XRAY XB4

TIP XB4 ANTI-ROLL BAR 2.0 MM

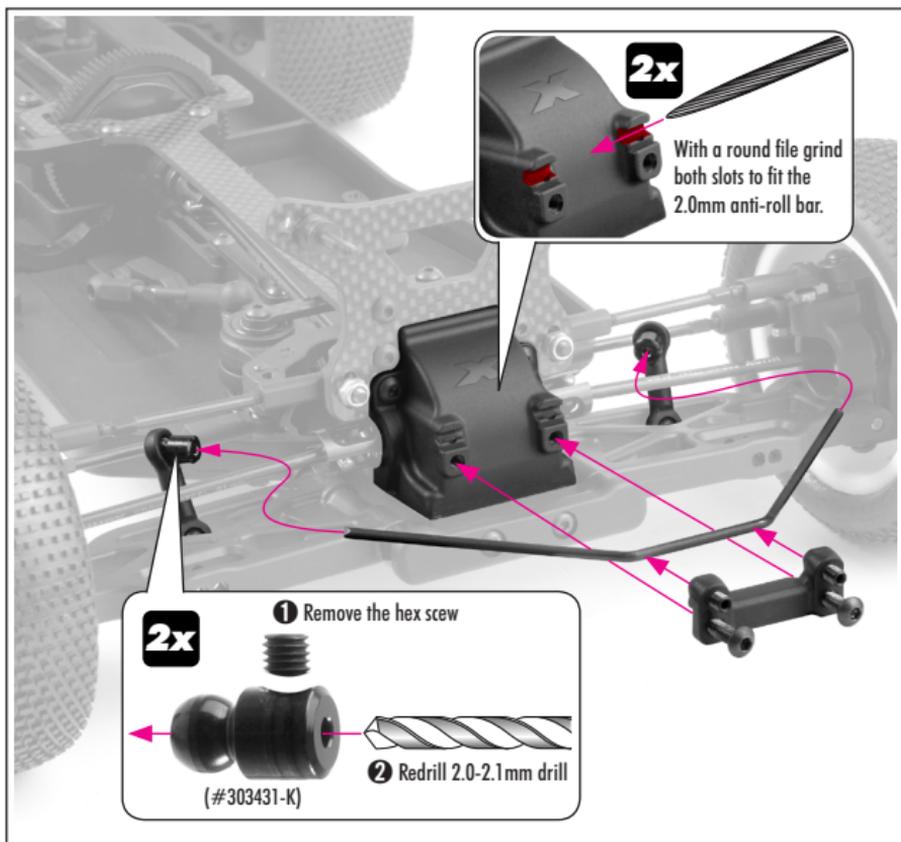
To fit the new optional #362480 Anti-Roll Bar 2.0mm a slight modifications has to be done. We suggest you to use a small round file and grind the slots on the diff bulkhead where the anti-roll bar sits to fit it properly. Next step is to redrill the hole for anti-roll bar in the #303431-K with the 2.0mm drill.
